**Errata to**
Geothermal Heating and Cooling: Design of Ground-Source Heat Pump Systems

**(2015)**

March 18, 2021

Figure 1.6   Unitary-Loop GCHP with Each Heat Pump Connected to Individual Loops

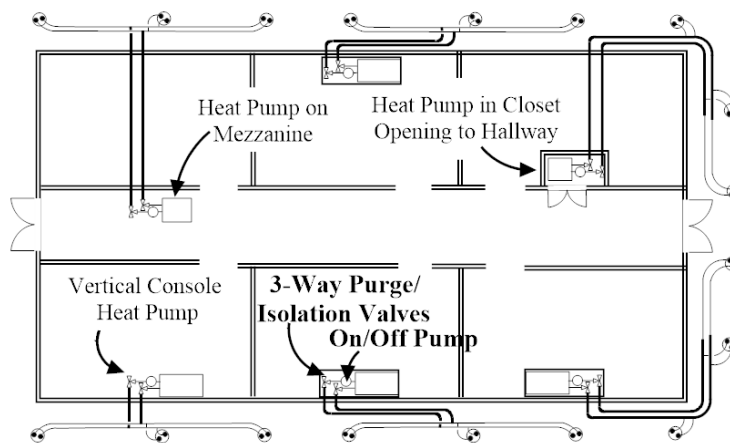
Page 9:   Figures 1.6 and 1.7 were inadvertently printed with elements of the drawings missing. Please see the corrected **Figures 1.6 and 1.7** below.

Figure 5.8   Heating-Mode Design Lengths for HDPE SWHEs (SI Units)

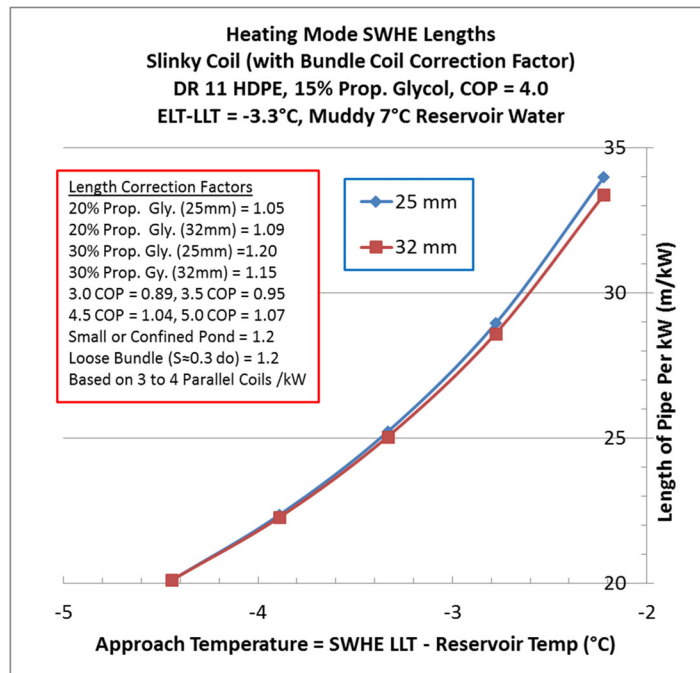
Page 150:   In Figure 5.19, in the red-bordered box, change "30% Prop. Gly. (25 mm) = 1.15" to "30% Prop. Gly. (**32 mm**) = 1.15." See the corrected figure below.

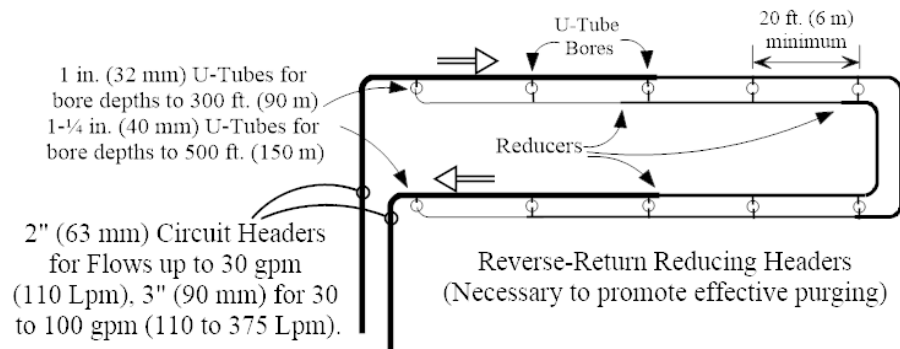
Page 173: Change Equation 5.27 from

$$S_f = \frac{2\pi L}{\cos h^{-1}\left(\dfrac{D^2 - r_1^2 - r_2^2}{2r_1 r_2}\right)}$$

to

$$S_f = \frac{2\pi L}{\cos \mathbf{h}^{-1}\left(\dfrac{D^2 - r_1^2 - r_2^2}{2r_1 r_2}\right)}$$

Add the following to the nomenclature listed after Equation 5.27:

$\cosh^{-1}$ = inverse hyperbolic cosine
